Alachua County Budget and Fiscal Services Procurement

RE: Addendum #1
RFP 22-307 Architectural & Engineering Services for the Budget Inn Conversion

**BOUNDARY & TOPOGRAPHIC SURVEY OF
TAX PARCEL #07222-000-000
& TAX PARCEL #07220-001-000
BEING A PORTION OF LOT 22,
SERENOLA PLANTATION AS PER
DEED BOOK "L", PAGES 480 & 481
TOWNSHIP 10 SOUTH, RANGE 20 EAST
ALACHUA COUNTY, FLORIDA**

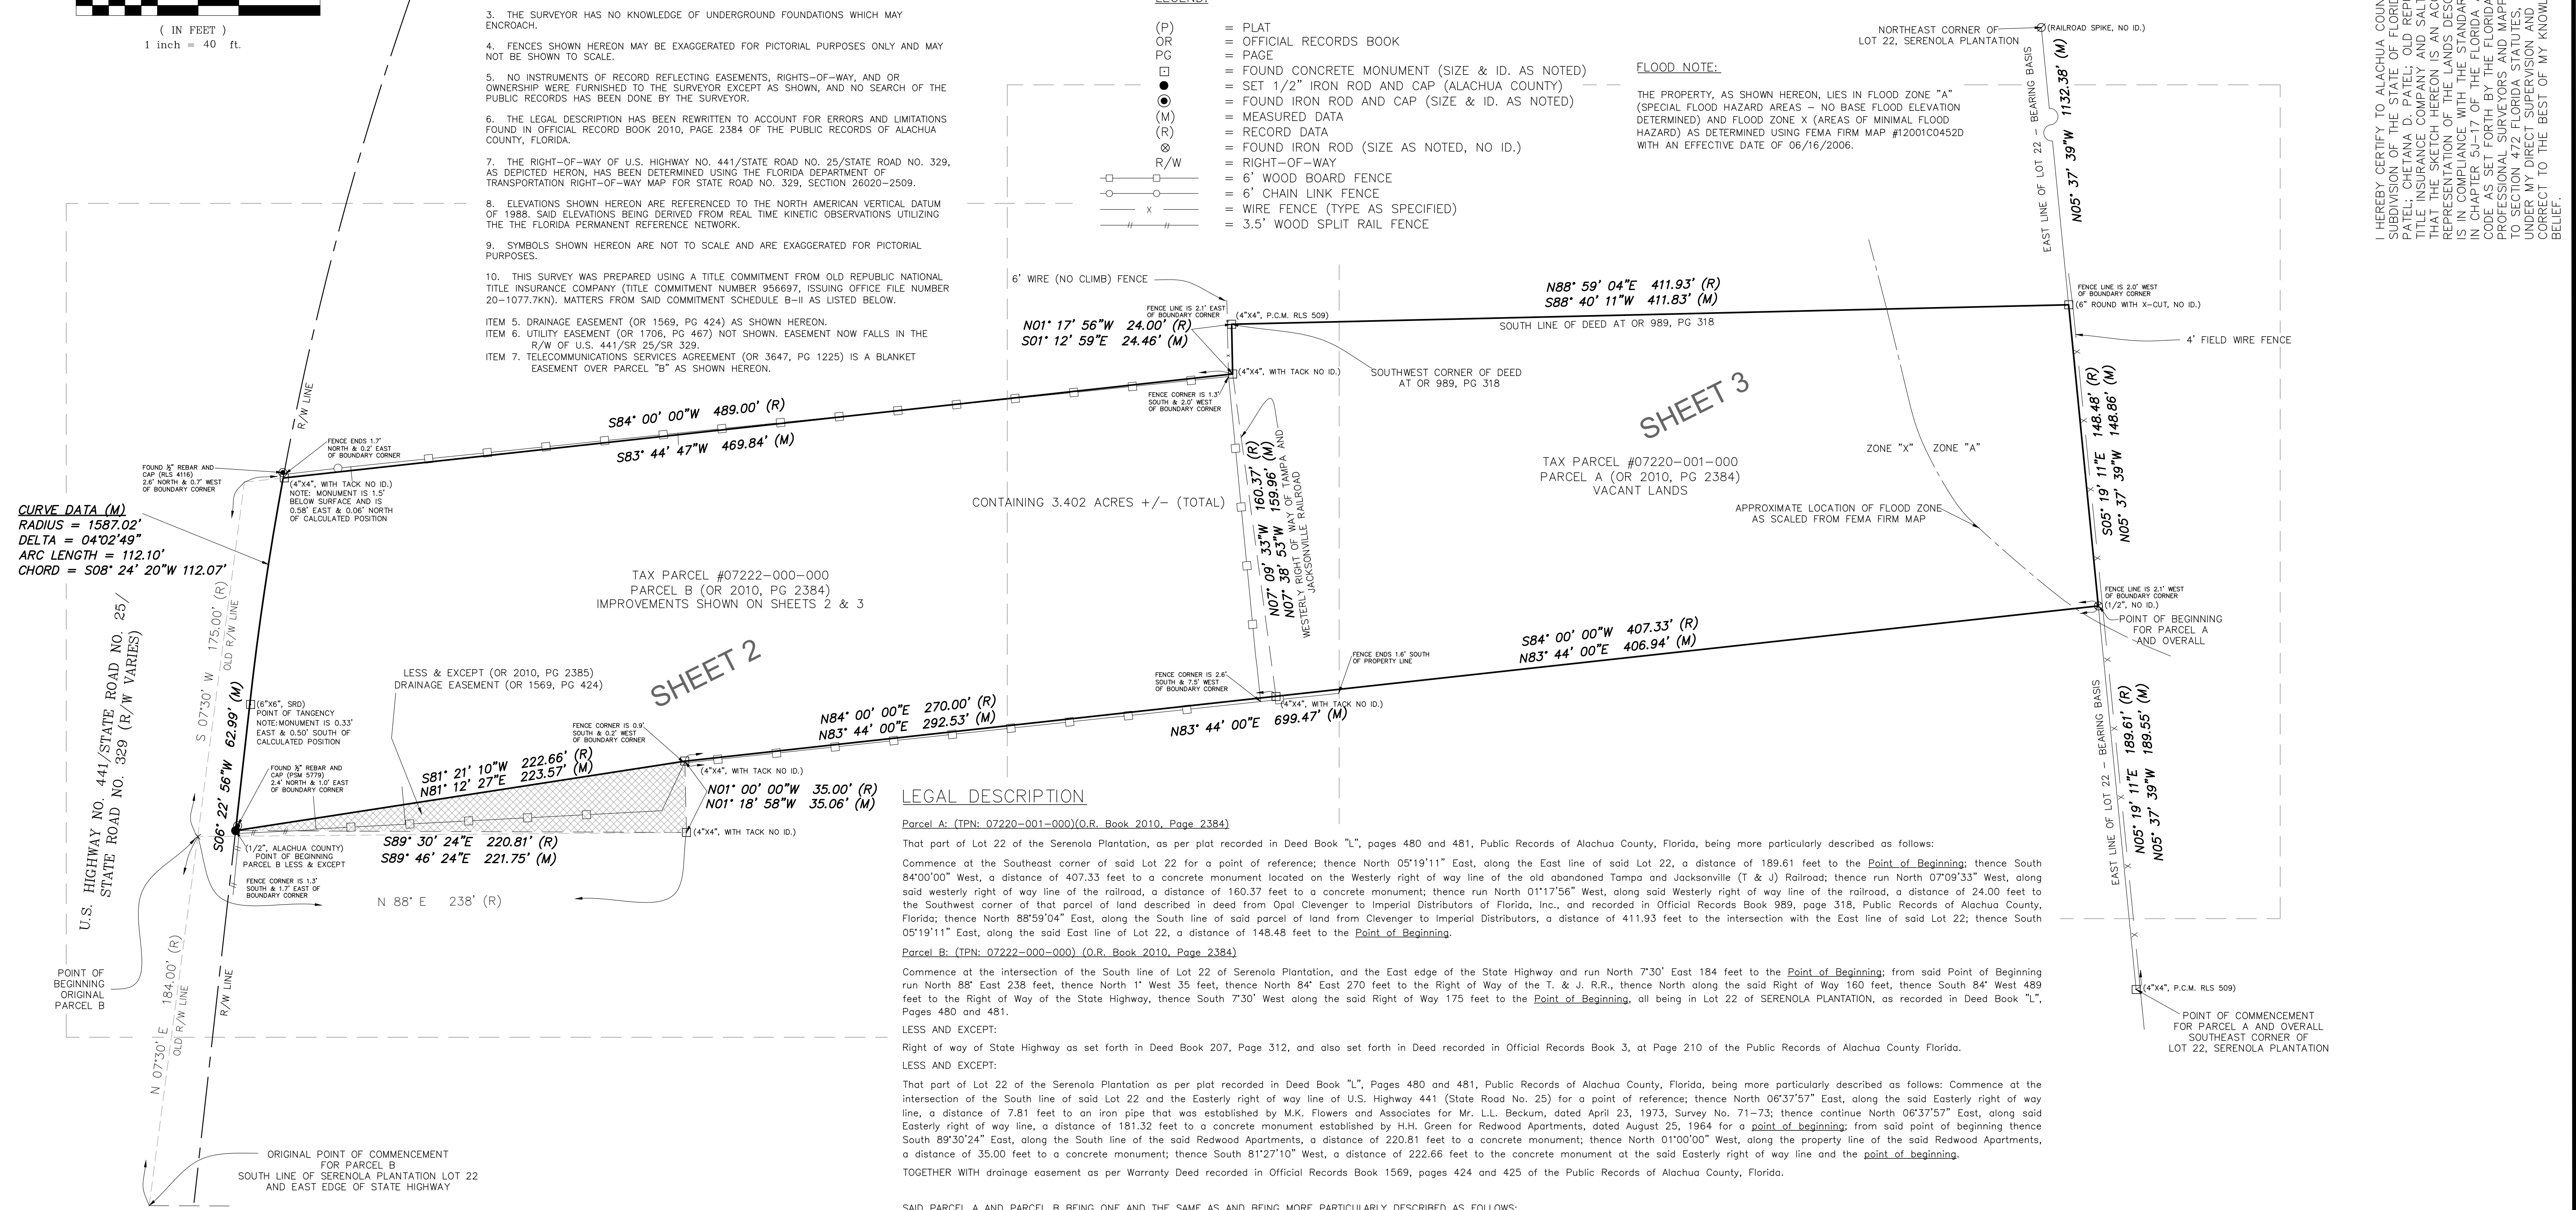
Q1: Does the county have a site plan or survey of the existing site, and can this be provided?

A2: **See Attachment**
